## **Product Change Notice**

### **FPC-08WA1 & FPC-08W04 Series Change**

- **Notification #:** 2011030001
- **Date of Publication:** Mar. 15, 2011
- **Affected Model:** Listed Below
- **Change Description**

Comparison 1

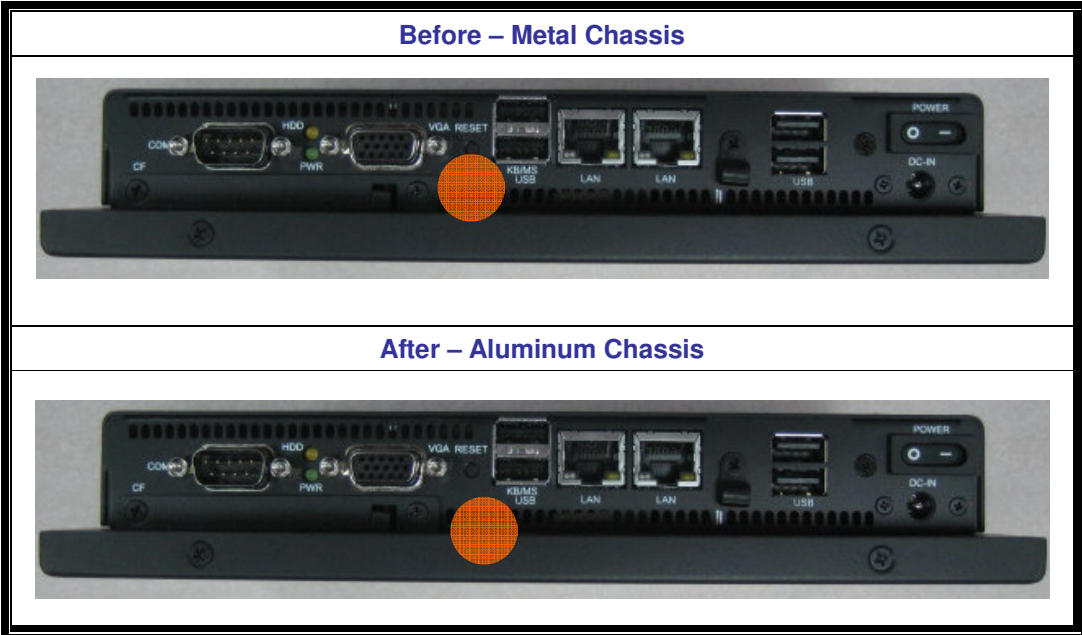
Regarding the FPC-08W series, the DC in connector is replaced from unlockable to lockable type with the matching lockable adapter, and the chassis is changed from the metal to the aluminum by losing the weight from 1.41 Kgs to 1.26 Kgs.
